POWER PLANT - DRAIN TUBE MAST - DRAINS COLLECTING BRACKET WITH INCREASED SEALING AREA  
- CATEGORY CODE 6 - MOD.ENG-71-0153

V2500-ENG-71-0153

## SERVICE BULLETIN

Location of drains mast tube assembly  
Fig.1

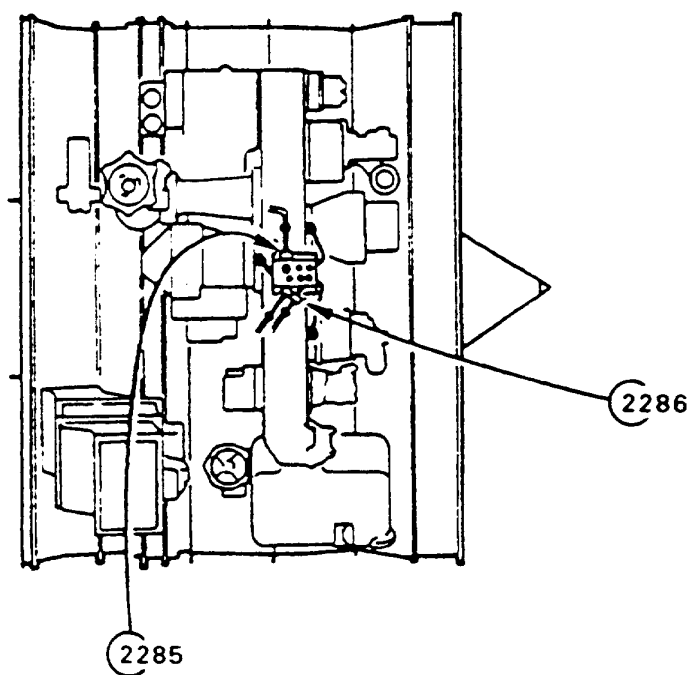
- (1) Find the drains mast bracket assembly. Refer to Figure 1.
- (2) Remove and discard the lockwire, then disconnect the six drains mast tube nuts from related connections. Refer to Figure 1 and Figure 2.

View on drains mast bracket at B.D.C. - Before and after alteration  
Fig.2

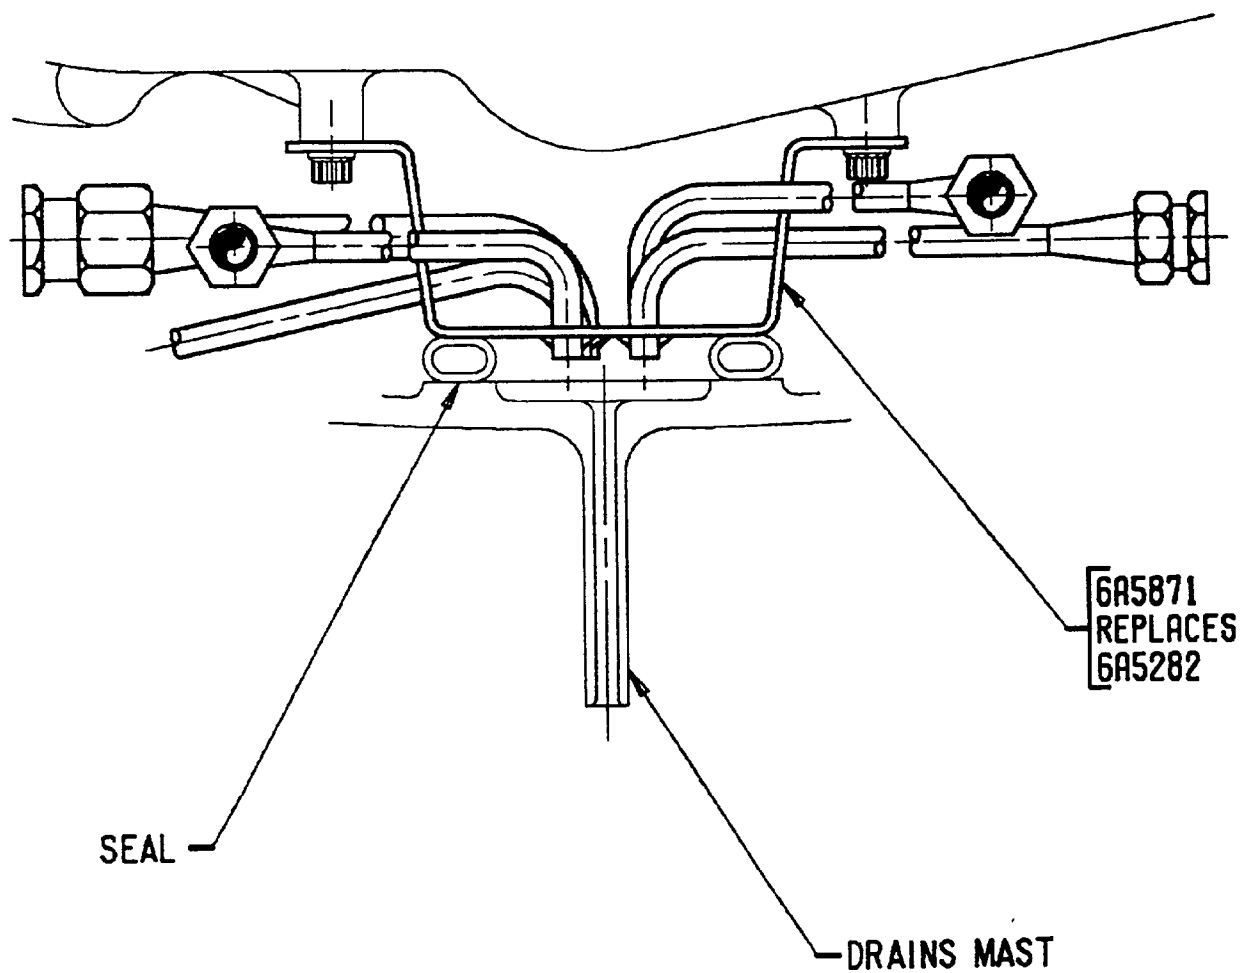
The sealing area of the drains collecting bracket is insufficient to accommodate lateral movement of the drains mast compressible seal mounted on the lower cowl door. This can permit oil leakage and damage to the compressible seal when in contact with the edge of the bracket.

This Bulletin introduces a new drains collecting bracket with an increased seal land surface. The new bracket also features a side wall opening scalloped to maintain the existing clearance with the fuel pump drains tube.

- (5) Remove 6A5282 drains mast bracket, leaving CP2607 retaining bracket.
- (6) Install new 6A5871 drains mast bracket and position CP2607 retaining bracket.
